Engineering Change Notice

Title	Diamond 4 motherboard reset cable
ECN Number	ECN-0157
Equipment	D4 Vision and D4 Elite
Author	Adam Proffitt
Drawing Number	
Date	31/03/05

Reason for ECN	Static discharges can cause pc motherboard to reset
Special Parts required	None
Special Tools required	None (An opened out small paper clip may be useful)

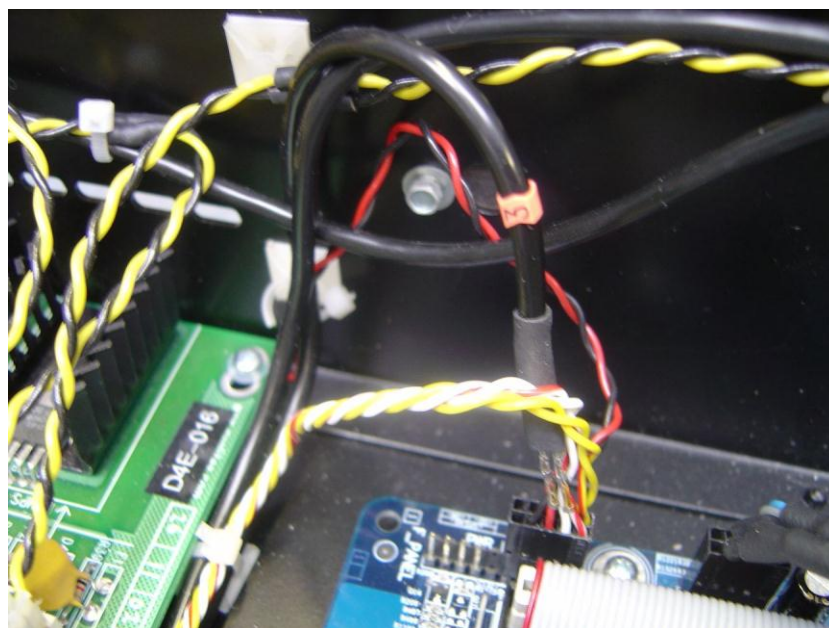
You need to remove the reset wires from the motherboard power/reset/led connector.

The two reset wires are in a sheathed cable (normally with a cable marker '3').

These two wires should be released from the connector block taking care not to disturb the other connections. The pins are released from the connector by pressing in the tab which can be seen on the edge of the connector - an opened out paper clip can be used for this.

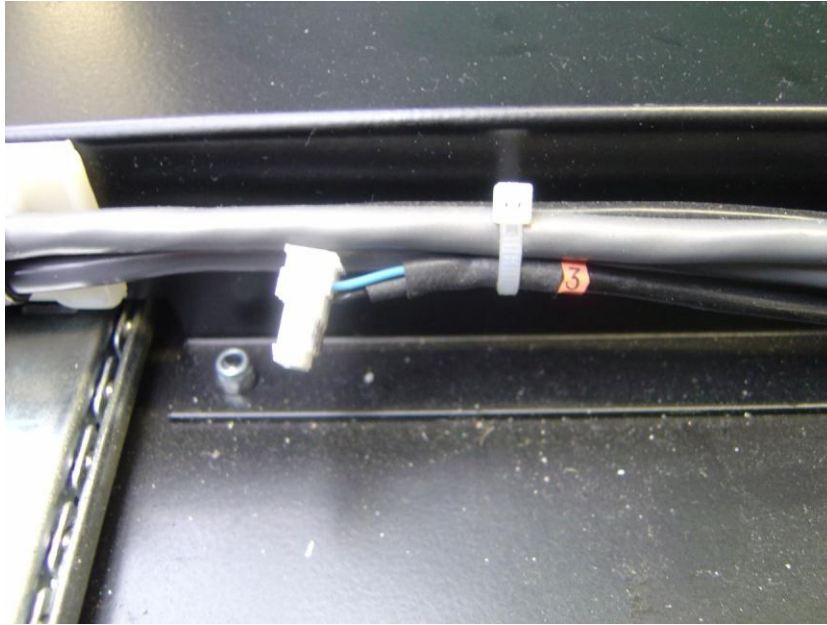
For your information, the opposite end of the cable terminates near to the EZ-DMX board on the base of the desk, but will not be connected (see next photo).
